SITE INSTRUCTION

PROJECT: HAMPTON MANOR
25 BAKER HILL BLVD
STOUFFVILLE, ONTARIO

SITE INSTRUCTION: M-27

Purpose: Add gas line for patio BBQ as requested.

DRAWN	CHECKED	SCALE
GC	BT	1:100
DATE	PROJECT	DRAWING
JUNE 2015	14-016	M-4
		OF 42

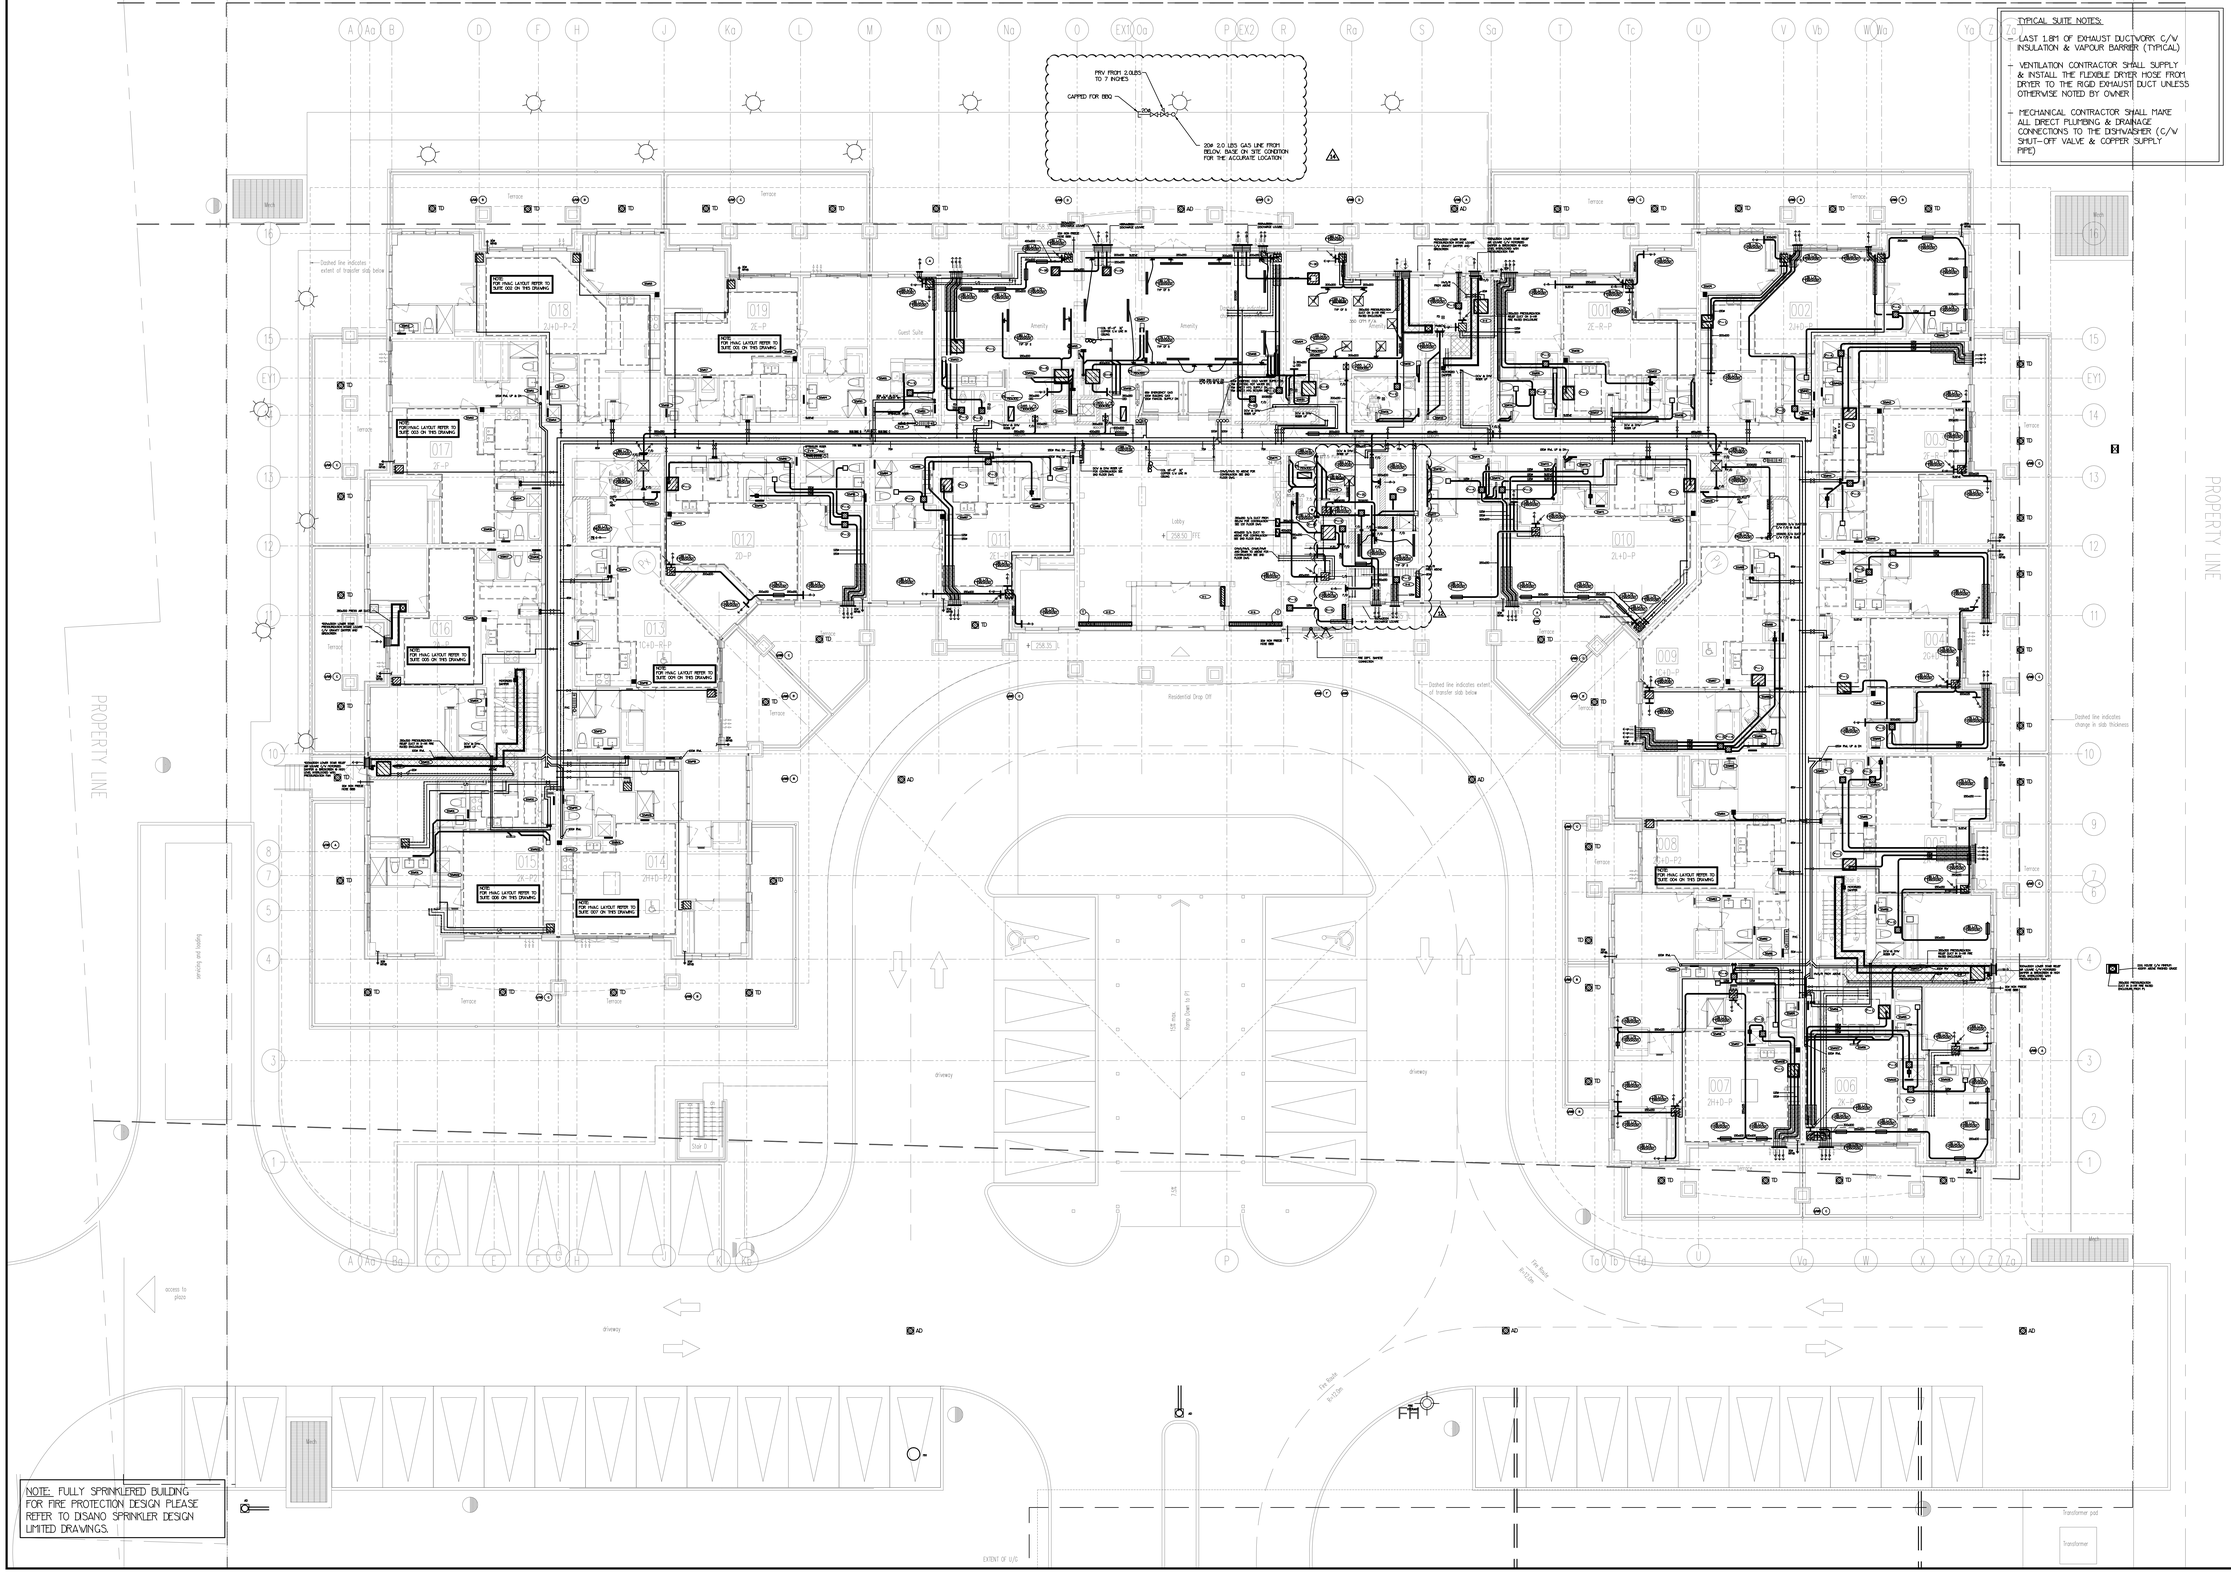
1.0 Reference Drawing M-4 (Parking Level Plan) Issued

1.1 Add: 2.0 lb gas line to bottom of patio BBQ.

20ø 7 INCHES GAS LINE UP FOR PATIO BBQ
